Evaluation of a Proposal for Cyanide Extraction of Gold and Silver from Mine Waste at the Leadville Mill, Lake County, West-Central Colorado

Steven H. Emerman, Malach Consulting, 785 N 200 W, Spanish Fork, Utah 84660, USA, Email: SHEmerman@gmail.com, Tel: 1-801-921-1228

Report prepared at the request of Concerned Citizens for Lake County, submitted July 23, 2024

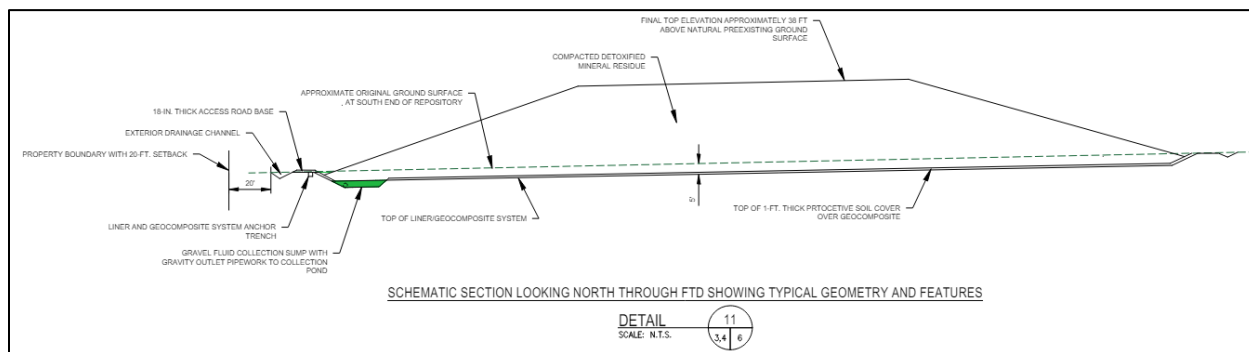
Figure 14. The filtered tailings deposit (FTD) would be constructed from partially dewatered tailings that had been compacted to within 90% of the maximum dry density. The industry standard is to construct a perimeter of tailings with the appropriate water content for maximum compaction (called the structural zone) and to place the tailings that are too wet for maximum compaction in the center (called the non-structural zone). The structural zone serves the same function as a dam. The industry standard is that the structural zone is compacted to within 95% of the maximum dry density, while the non-structural zone is compacted to within 90% of the maximum dry density. In other words, the FTD would be constructed with no structural zone, which is one of the factors that lead to the conclusion that the FTD will be unstable as designed. Although the diagram states that the approximate height will be 38 feet, elsewhere Union Milling Company states the approximate height as 38 to 43 feet. Portion of figure from Union Milling Company (2024).

The two variations on the target water content are not related to any measurements of the optimum water content for maximum compaction, which would be the standard procedure, but only to the water contents that currently have been achieved by filtration tests on tailings samples. Through a series of nine tests on filtration of tailings, Union Milling Company (2024)

The third reason as to why the filtered tailings deposit (FTD) will be unstable is that the FTD will be constructed without any structural zone or dam for proper confinement of the tailings that will be too wet for adequate compaction (see Fig. 14). According to Union Milling Company (2024), “A series of field trials will be carried out to allow for a method specification for filtered tailings placement that produces densities at field scale that [are] compliant with a target 90% of maximum Proctor Density requirement [maximum dry density based upon a specific test].” The standard procedure is to construct a structural zone in which the tailings are compacted to 95% of their maximum dry density and a non-structural zone in which the tailings are compacted to 90% (sometimes as low as 85%) of their maximum dry density. As discussed previously, the structural zone is constructed out of the tailings with the appropriate water content for adequate compaction, while the non-structural zone is constructed out of the tailings that are too wet for adequate compaction. In essence, the plan for the FTD is to construct only a non-structural zone without any structural zone (see Fig. 14).

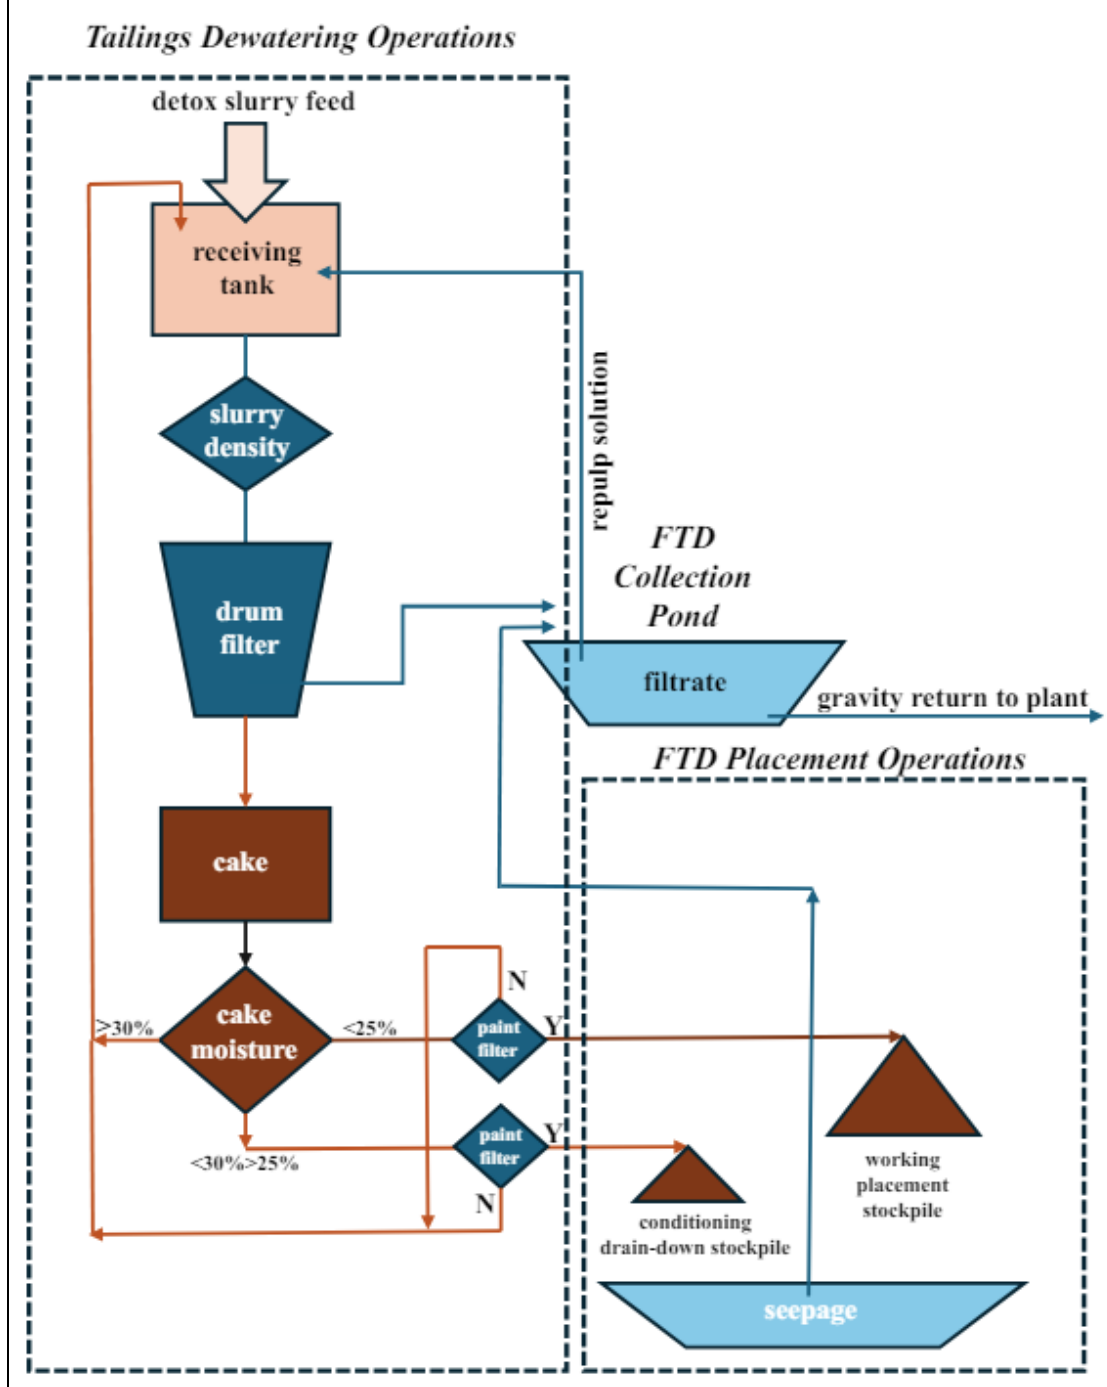
Figure 16. Although Union Milling Company (2024) sometimes states the target water content for the filtered tailings deposit as the range of 20% to 30%, the above diagram shows that filtered tailings will be sent to the filtered tailings deposit only if the water content is less than 25%. Only a maximum water content (as opposed to a range) is not standard for filtered tailings technology because tailings could be too dry for appropriate compaction and excessive dryness could lead to dust generation and lack of trafficability. The Paint Filter Test is an EPA lab test for the presence of free water. It is difficult to imagine how this lab test could be applied to all output from the filter presses. Although not stated, it is assumed that target water contents refer to the process water content, not the geotechnical water content. Figure from Union Milling Company (2024).

One version of the procedure for determining whether the filtered tailings are dry enough for compaction shows all tailings being subject to a Paint Filter test as the tailings leave the filter presses (see Fig. 16). The Paint Filter test is an EPA (2024c) lab test for determining whether a sample includes free water (water that is not confined to pore spaces). According to Union Milling Company (2024), “Tailings are only to be delivered to the FTD transfer conveyor when the drum filter is producing filter cake within at or below the target lower limit of 75% solids (25% water content). Filter cake that has water content above this limit (i.e. >25%) could be acceptable for placement if it passes the Paint Filter Test and may be placed in the stockpile on a system upset basis and allowed to drain down to water content that allows for effective spreading and compaction. Continuous testing of filter cake allows for warnings to trigger a response plan as illustrated on Figure 4-23 [Fig. 16 in this report]. The primary and ultimate acceptance criterion for filter cake into the FTD is passing the Paint Filter Test (no free water bleed).” It is difficult to imagine how the entire output of the drum filters could be subjected to such a lab test, although that is what is stated above and shown in Fig. 16. Even so, the tailings with a process water content in the range 25 to 30% and, which show no free water according to the Paint Filter test, would not be filtered any further, but only allowed to drain under gravity (see Fig. 16). This drainage under gravity would reduce the water content only to the saturated water content or slightly less than the saturated water content. The implications of placing saturated or near-saturated tailings in the filtered tailings deposit will be reviewed in the “Responses” section. It is noteworthy that the application by Union Milling Company (2024) never states the tailings water content that would constitute saturation for comparison with the various alternatives for target water contents.

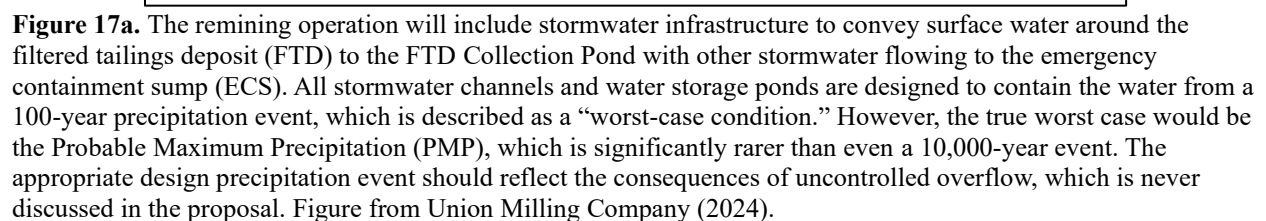
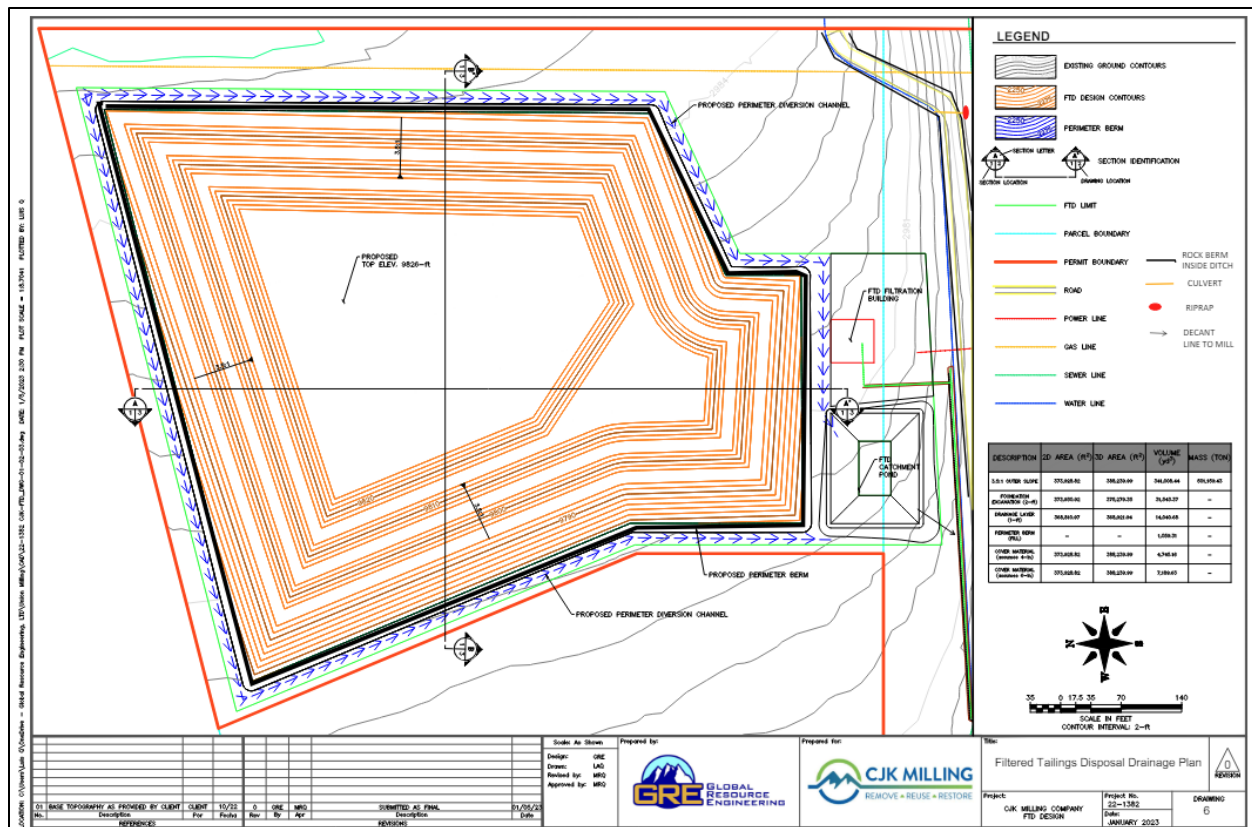
The proposed stormwater management plan for the Leadville Mill is shown in Figs. 17a-b and 18. Diversion channels would convey stormwater around the filtered tailings deposit and into an FTD Collection Pond at the downstream end of the FTD (see Figs. 17a-b). Fig. 18 shows the mill site divided into three drainage areas. Stormwater in Drainage Area 1 would flow into a pre-existing emergency containment sump (ECS) (see Fig. 18). Stormwater from Drainage Area 2 would flow around the ECS, into a sediment trap, and then into California Gulch, while stormwater from Drainage Area 3 would flow directly into California Gulch with no sediment capture (see Fig. 18). The FTD and the FTD Collection Pond would probably be in Drainage Area 2, so that any overflow from the FTD Collection Pond would probably flow into California Gulch after sediment capture. The stormwater management plan is difficult to interpret because, while the permit boundary covers 42.93 acres and the affected land covers 42.60 acres (Union Milling Company, 2024), less than 20 acres is accounted for in the stormwater management plan (see Fig. 18).

All stormwater infrastructure would be designed to accommodate a precipitation event with a return period of 100 years, that is, an event with an annual probability of exceedance of 1%. According to Union Milling Company (2024), “For representative purposes, 100-year storm events were modeled to provide base case design and estimates of anticipated flows for an

extreme event ... The FTD Collection Pond will retain the water from a 24-hour, 100-year discharge from the tailings disposal area under worst-case conditions of storm occurrence prior to the placement of any filtered tailings ... The ECS pond will retain the water from a 24-hour, 100-year discharge.” Further information about the proposal for remining at the Leadville Mill will be provided, as needed, in the “Responses” section.

deposit (FTD) will be permanent, as was discussed in the subsection “There is no Plan for Safe Closure of the Filtered Tailings Deposit.” Thus, the threat of an uncontrolled overflow of the stormwater diversion channels (see Figs. 17a-b) onto the FTD will be permanent. There is a conceivable future in which, due to climate change, the stormwater diversion channels will be significantly underdesigned. It must also be pointed out that there is no plan for long-term maintenance of the FTD, which should include such obvious tasks as cleaning the stormwater diversion channels.

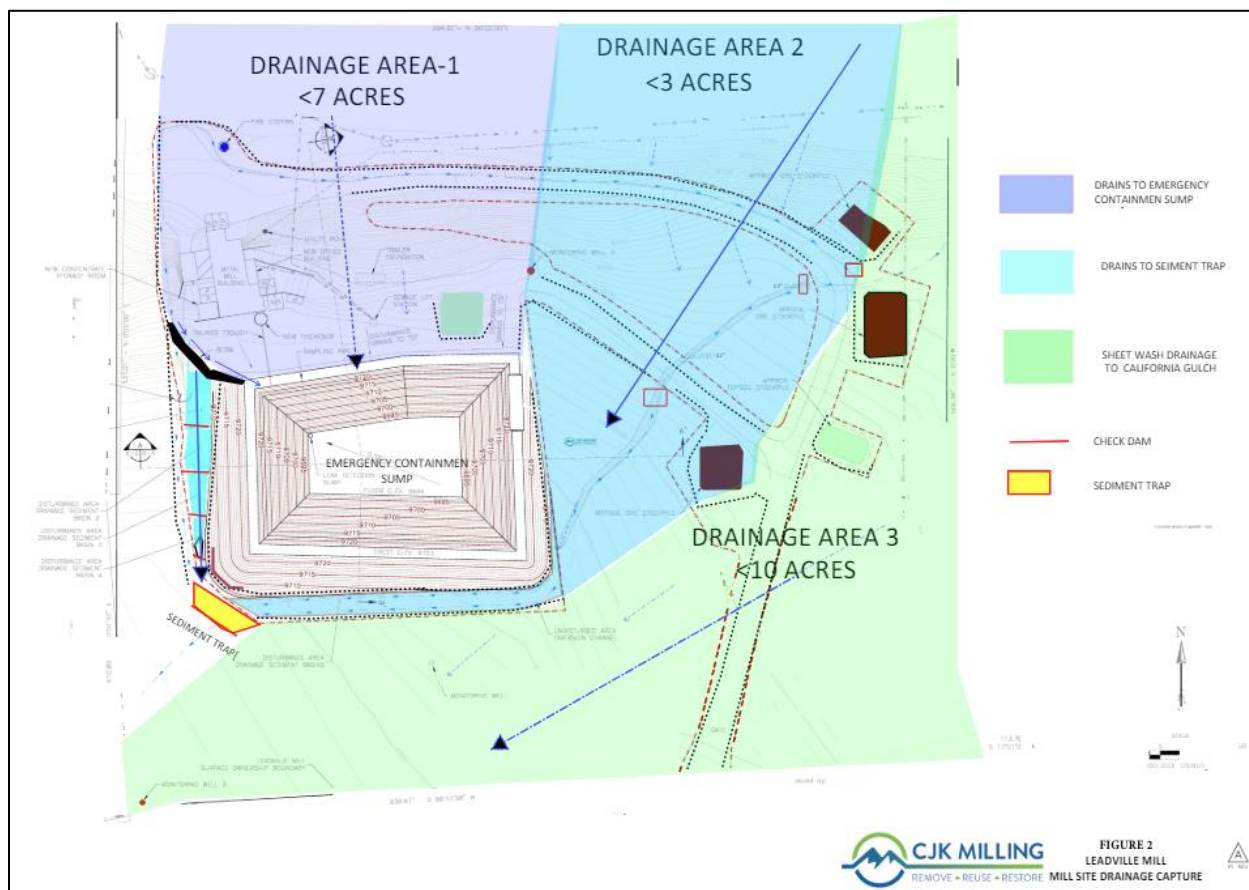
- 1) The permit application has multiple versions of the permit boundary and the perimeter of the filtered tailings deposit (FTD) (compare Figs. 17a-b, 19a-b and 23). For example, some components of the stormwater management plan are based on one version of the FTD perimeter, while other components are based upon a different version of the FTD perimeter (compare Figs. 17a and 17b).
- 2) While the permit boundary covers 42.93 acres and the affected land covers 42.60 acres, less than 20 acres is accounted for in the stormwater management plan (see Fig. 18).

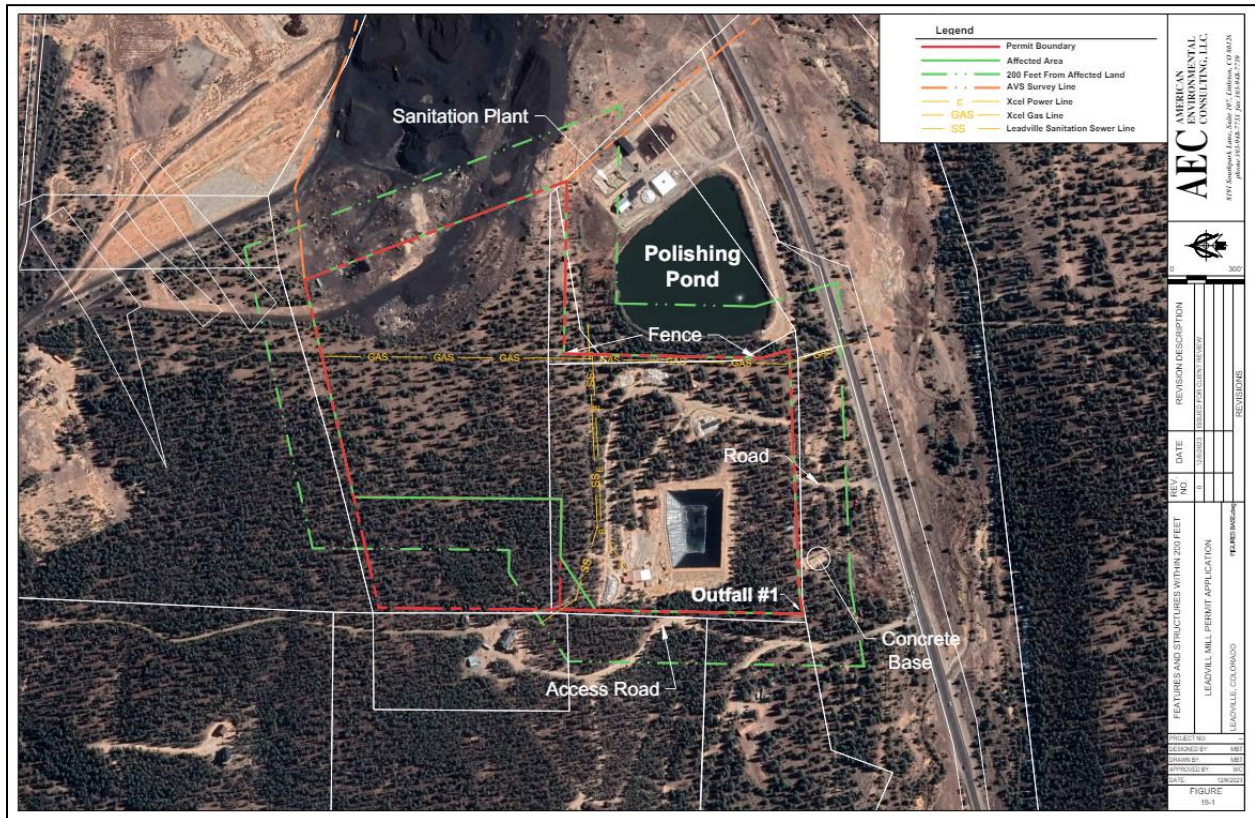
Figure 19a. The permit boundary for the maps in this report (see Figs. 2, 22, 28, 30, and 31) was constructed by comparing the above map from Union Milling Company (2024) with Google Earth imagery from October 2, 2019. The permit boundary is similar in some maps (see Figs. 17a) in Union Milling Company (2024), but completely different in other maps (see Figs. 17b, 21, and 23).

Figure 19b. The perimeter of the filtered tailings deposit (FTD) for the maps in this report (see Figs. 2, 22, 28, 30, and 31) was constructed by comparing the above map from Union Milling Company (2024) with Google Earth imagery from October 2, 2019. The perimeter is similar in some maps (see Figs. 17a) in Union Milling Company (2024), but completely different in other maps (see Figs. 17b, 21, and 23).

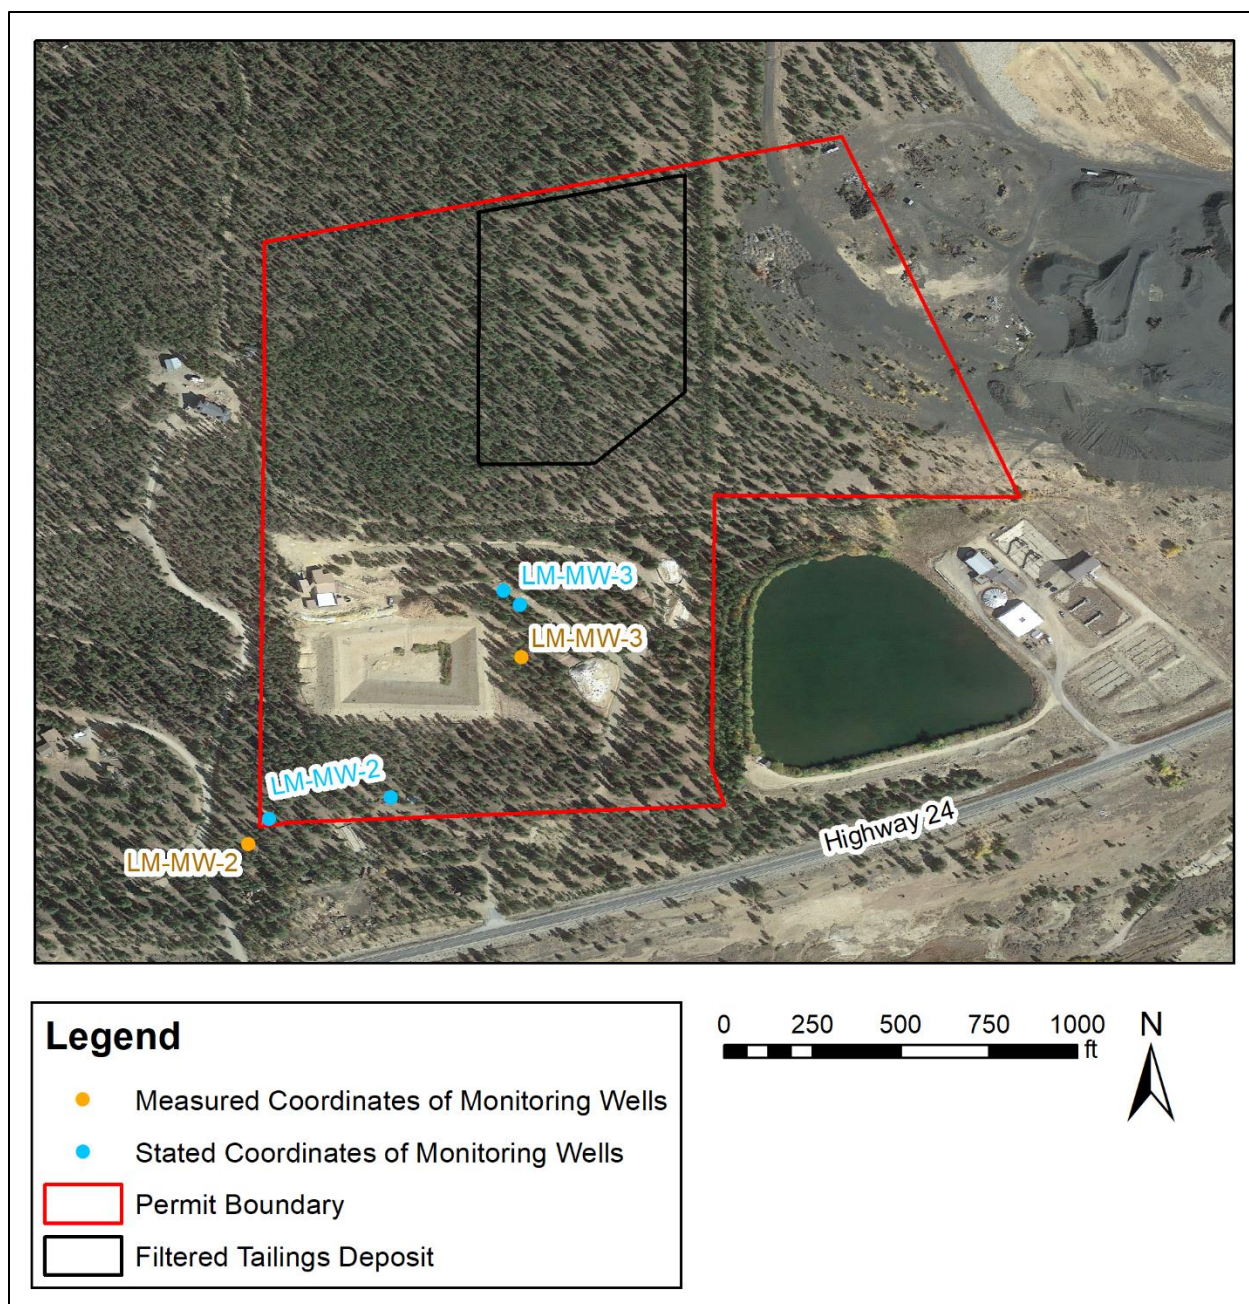
Figure 22. The mapped locations of the seven monitoring wells (see Fig. 21) were compared with Google Earth imagery from October 2, 2019, to determine the coordinates (see Table 2). In addition to the map, Union Milling Company (2024) stated two different sets of coordinates for LM-MW-2 and LM-MW-3 (see Table 2). For LM-MW-2, the mismatch between the two sets of stated coordinates is 275 feet. The mismatches between the measured coordinates and the first and second sets of stated coordinates are 86 feet and 340 feet, respectively. For LM-MW-3, the mismatch between the two sets of stated coordinates is 51 feet. The mismatches between the measured coordinates and the first and second sets of stated coordinates are 148 feet and 190 feet, respectively. The map in Union Milling Company (2024) (see Fig. 21) clearly shows that monitoring well LM-MW-2 is outside of the permit boundary, while the two sets of coordinates stated by Union Milling Company (2024) for LM-MW-2 would place the monitoring well inside of the permit boundary. Permit boundary traced from Fig. 19a and perimeter of filtered tailings deposit traced from Fig. 19b. Background is Google Earth imagery from October 2, 2019.

- 1) There are three different versions of the locations of monitoring wells LM-MW-2 (the point of compliance) and LM-MW-3 (see Figs. 20-22 and Table 2).
- 2) The locations and depths of the monitoring wells were chosen without any knowledge of the local and regional hydrogeology.
- 3) Monitoring wells LM-MW-2 and LM-MW-3 (see Figs. 20-22) were persistently dry during the period of collection of baseline data, so that those wells did not serve any useful purpose.
- 4) Most of the data were missing for monitoring well MA1TMW-4 without any explanation.
